LOCAL MEMBER/AM OBJECTION/PETITION

APPLICATION No. **15/01137/MJR** APPLICATION DATE: 18/05/2015

LOCATION: 38-48 CRWYS ROAD, CATHAYS, CARDIFF, CF24 4NN

PROPOSAL: CONVERSION AND EXTENSION OF THE EXISTING BUILDINGS ON SITE TO FORM A 4 STOREY DEVELOPMENT FOR STUDENT ACCOMMODATION WITH THE RETENTION OF THE EXISTING RETAIL UNITS AND RESTAURANT

Site Plan @ 1:250 @A1 / 500@A3

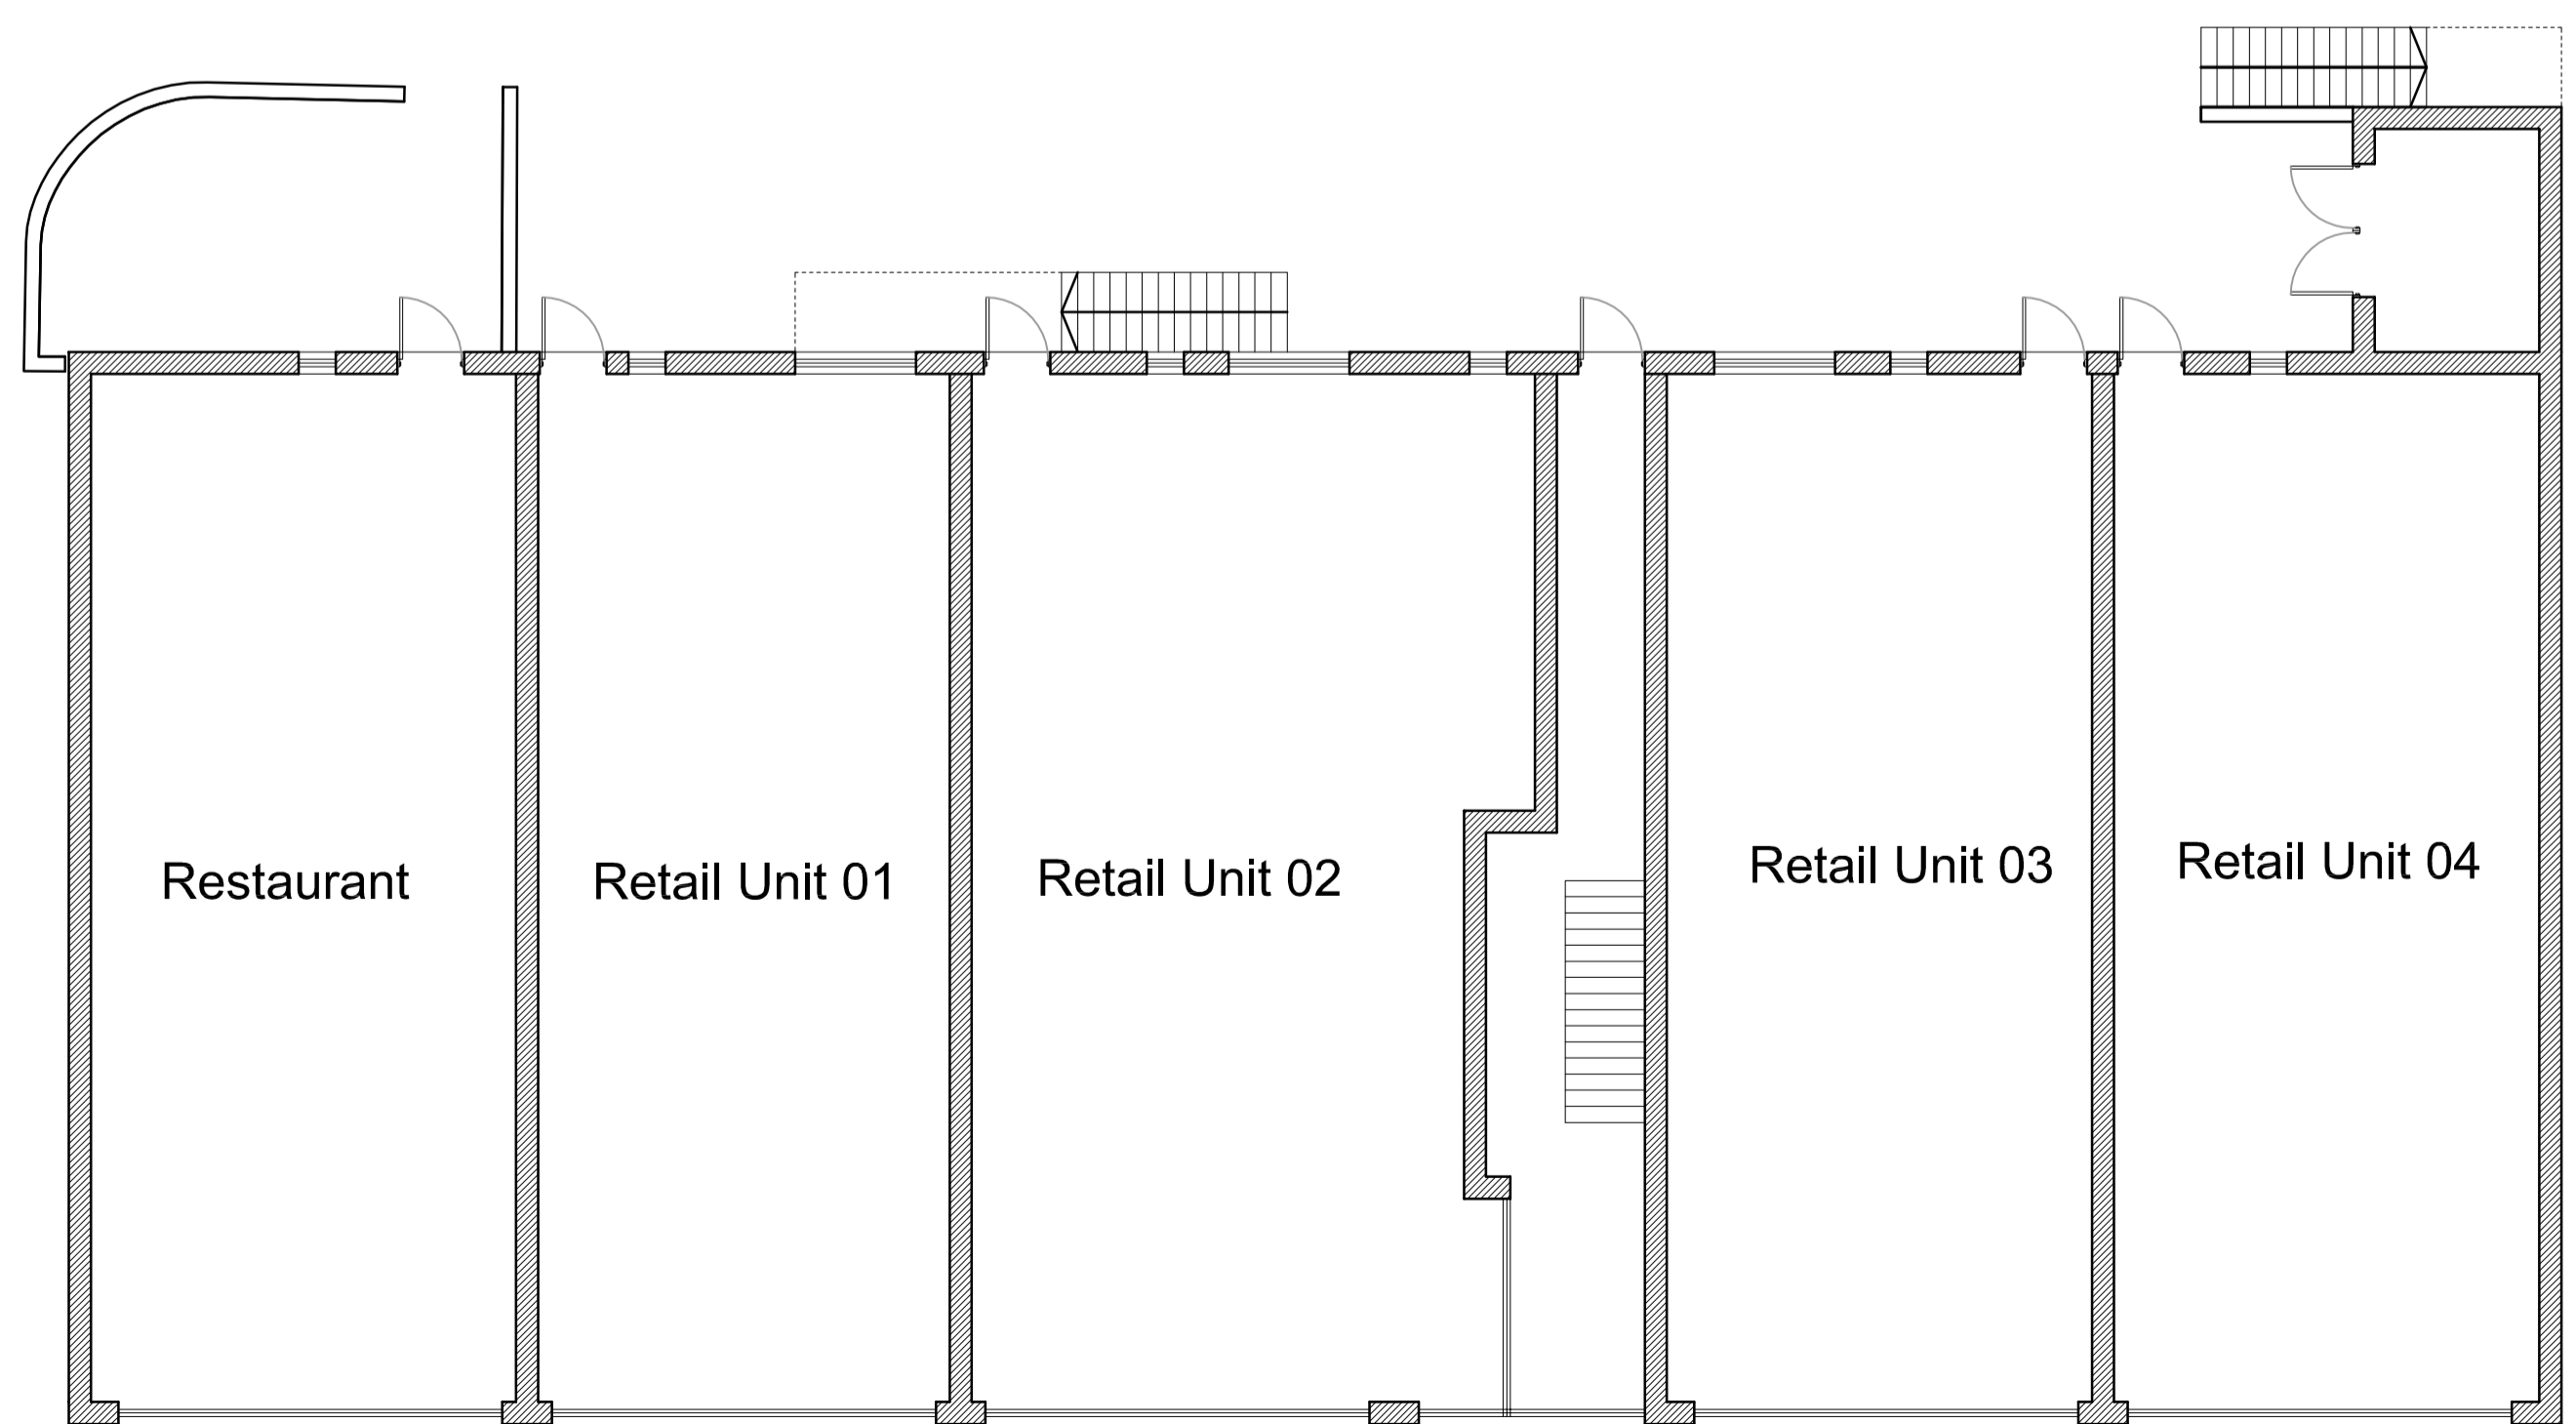
The small courtyard shown on drawing 14-051_AL(90)10 proposed site plan is too small to be considered as recreational open space and will offer limited outdoor recreational activities for the occupants of the development.
